Response to Reviewers' Comments

Reviewer 1:

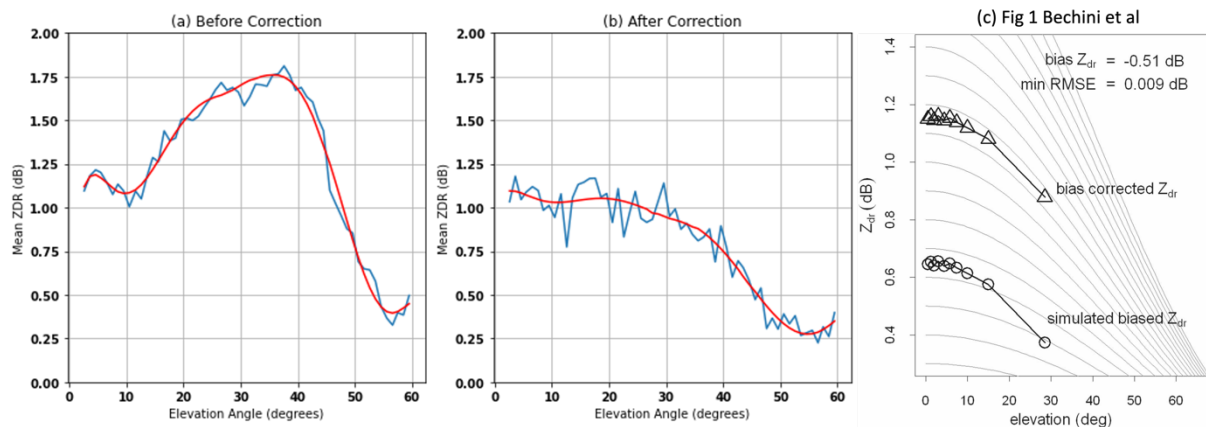
With the same method, the author tried to correct the “azimuth” variability of ZDR and PHIDP on PPI scan and to correct “vertical” variability on a RHI scan.

According to my knowledge, it is too ambiguous to mix all these contents in the same investigation and attribute all of them to the radar radome.

For the RHI scan, it is well known that ZDR depends on the elevation angle (see Bechini et al. 2008: Differential Reflectivity Calibration for Operational Radars). If elevation angle is equal to 90° , the ZDR is expected to be around 0 dB, while ZDR is much larger than 0 dB for the elevation angle equal to 0° . This is totally due to the geometry of raindrops shape, but nothing related to the radome.

Thank you for your insightful comments and for referencing the Bechini et al. (2008) study. You are correct that ZDR depends on the elevation angle due to the geometry of raindrop shapes:- the ZDR decreases with increasing elevation angle. However, our study detected an anomalous increase in ZDR at certain elevation angles in our RHI scans, which suggests the presence of bias at specific elevation angles. We believe these biases are introduced by the radome joints, affecting the signal differently at various elevation angles.

Our correction algorithm is specifically designed to address these bias at specific elevation and azimuth angles. It does not alter the expected property of ZDR variation due to raindrop geometry. In Figure A (attached), we present the average ZDR observed across different

elevation angles in stratiform rainfall from the 300° RHI scan measurements between the 1 km and 2 km range near the radar over 10 consecutive time steps, focusing on uniform precipitation below the bright band. The 300° RHI scan angle was chosen because it exhibits minimal ground clutter at close range, due to the absence of significant orography in this direction. Prior to the correction, the ZDR profile showed an unexpected increase at certain elevation angles, deviating from the theoretical decrease expected from raindrop shape considerations alone. After applying our correction algorithm, these anomalies are effectively removed, resulting in a ZDR profile that aligns with the theoretical expectations Fig A(c) (i.e., decreasing consistently with increasing elevation angles). This correction enhances the accuracy of ZDR measurements, thereby fulfilling the criteria necessary to apply the Bechini et al. (2008) algorithm.

Figure B: . 76° RHI scan of ZDR measured on 3rd February 2022 01:08 UTC before correction.

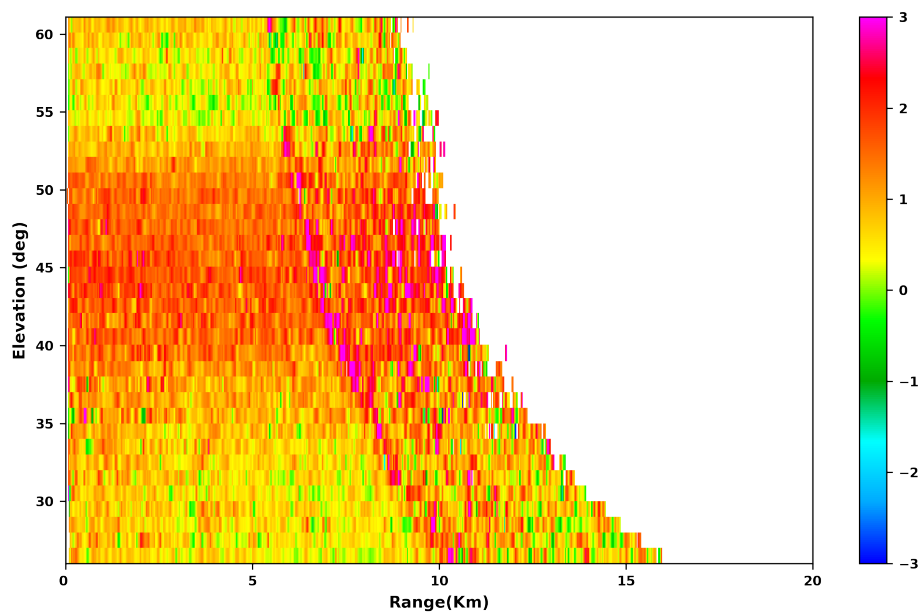
Comment 6: Consistency between Figures 2d and 3a: why is there no anomaly at 34° elevation angle in Figure 3a whereas this angle was chosen in Figure 2d to represent an angle for which ZDR has a bias?

Response 6: The figure B below presents a zoomed-in snapshot of Figure 3a, specifically focusing on the elevation angles around 27° and 60° . Our objective was to investigate the

source of bias in ZDR (Figure 2d) by selecting elevation angles based on the primary criterion that the biased and unbiased angles must observe the same type of precipitation. As evidenced in the figure below, the 34° angle marks a transition where we start observing the onset of radome-induced bias. The 34° angle was chosen because it is the closest elevation angle to 27° where the anomaly becomes visible, while still observing the same precipitation pattern as at 27° , which remains unaffected by radome-induced bias. The following statement has been appended in Page 3 lines 88 to 90 of the revised manuscript for clarification “ For example, the 34° angle marks the transition where the onset of radome-induced bias becomes visible and was chosen as it is the closest elevation angle to 27° (unbiased) that still observes the same precipitation pattern.”
